CERTIFICATE OF APPROPRIATENESS

Applicant: Gail Schorre, Morningside Architects LLP for Mark and Linda Margavio, owner

Property: 1832 Columbia Street, lot 20, block 108, Houston Heights Subdivision. The property includes a historic 1,036 square foot historic residence situated on a 6,600 square foot (50' x 132') interior lot.

Proposal: Alteration – *Deferral*: Construct a two story 1,584 square foot addition and attached two story rear garage with 400 square feet of living space to the rear of a one story contributing residence. The applicant initially submitted a COA application last month that staff found to not meet criteria 1, 4, 8, and 9 for alterations to Contributing structures. The application was deferred at the December 17, 2014 HAHC meeting in order to allow staff time to review revisions discussed at the meeting by the applicant. The applicant and owner have since met with staff and agreed to revise their previous design.

NORTH SIDE ELEVATION

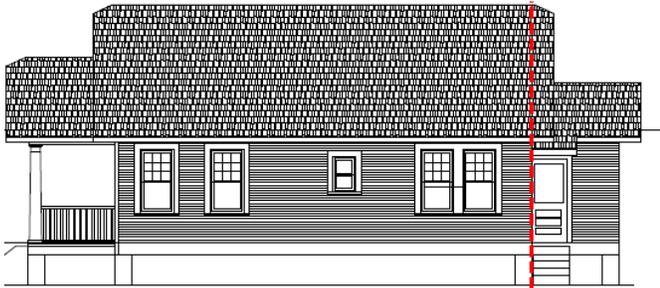
- Reduced the ridge height from 32' 6" to 28' 11" and the eave height from 22' 11" to 22' 4".
- Reduced the width of the addition from 33' 2" to 28' 3". The main portion of the addition will now measure the same width as the existing residence.
- Start the second floor of the addition at the rear wall of the existing structure eliminating any encroachment over it. The rear 7' of the north side wall of the existing house will now be retained.

Side Elevation: The addition will begin at the rear of the existing structure. The main portion of the addition will feature a band of 3 windows on the first floor and three windows on the second.

SOUTH SIDE ELEVATION

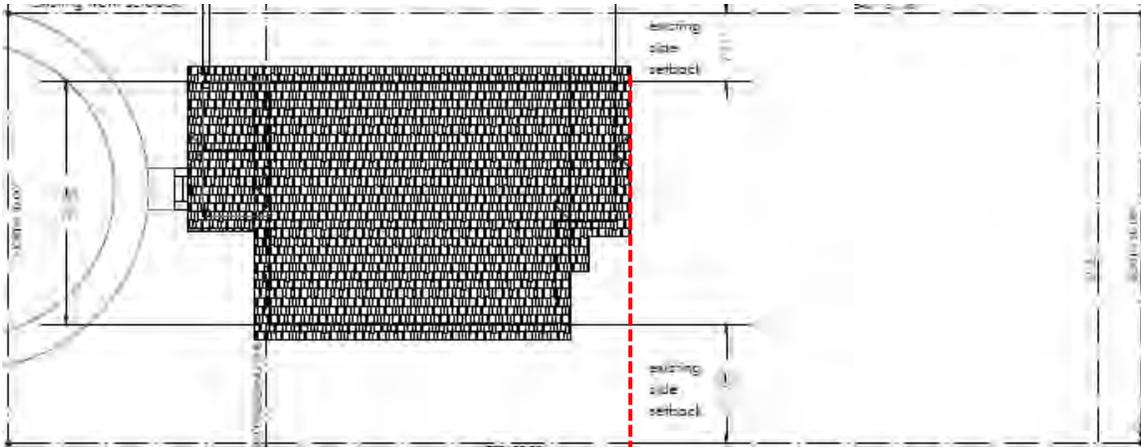
Side Elevation: The addition will begin at the rear wall of the existing structure. The main portion of the addition
(South) will feature two windows on the first floor and four on the second. The garage will be attached to the addition by a front facing carport.

PROPOSED SITE PLAN

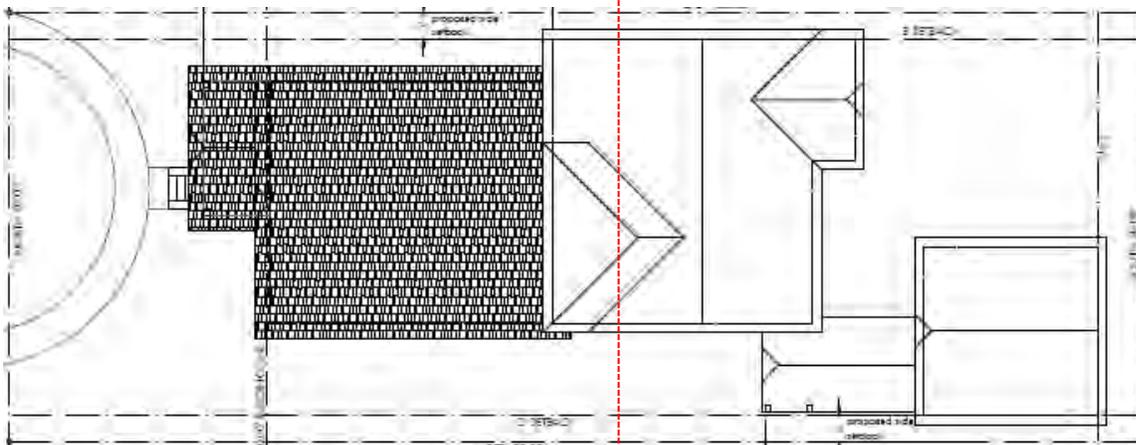
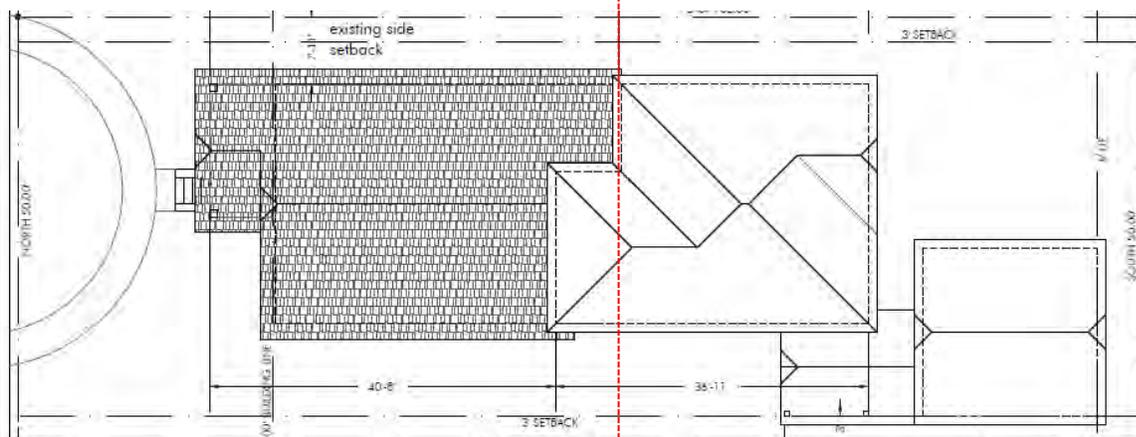
Setbacks: **Deferred 12/17/14:** *The existing residence is set back 23' 3" from the west (front) property line, 13' 9" from the south, and 7' 11" from the north. The main portion of the proposed addition will be built to within 3' of the north side setbacks but will not change the existing south setback. The proposed attached garage-carport portion will be set back 88' 3" from the front property line and will be built to within 3' of the southern property line but will not impact the north setback. When combined, the addition in its totality will extend to 3' of each side setback.*

Proposed Revision: The main portion of the proposed addition will not extend beyond the setbacks of the existing residence.
